PARTS BULLETIN

Reference		Date
PB-153	Door Gasket Change	7/14/22
Product	EH060, EH070, EH080, RMG070

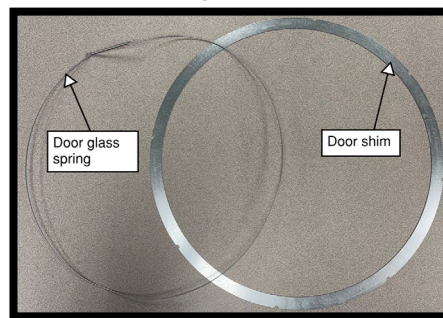
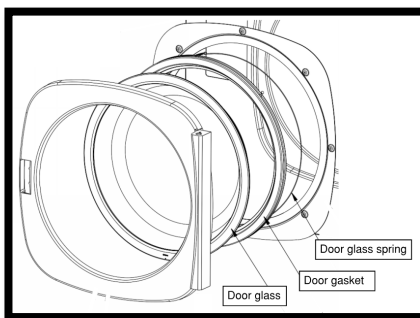
The door gasket on the EH060, EH070, EH080, and RMG070 has been changed to a new door gasket (**p/n 11916434**). All applicable equipment manufactured after August 1st 2022 will have this new door gasket. The new door gasket will be available as a service part.

1. Different durometer material
 - a. Material is more elastic, creating a tighter seal
2. Different profile
 - a. The new gasket has a tapered profile to better seal with the front shell opening

3. **NOTE: Door glass spring and door shim removal**
 - a. The door glass spring cannot be used with this new door gasket.
 - b. The door shim cannot be used with the new door gasket.
 - c. The door catch shims cannot be used with the new door gasket.

The part number for the **new gasket** is **11916434**. The original gasket (p/n 563346) will still be an active part number.
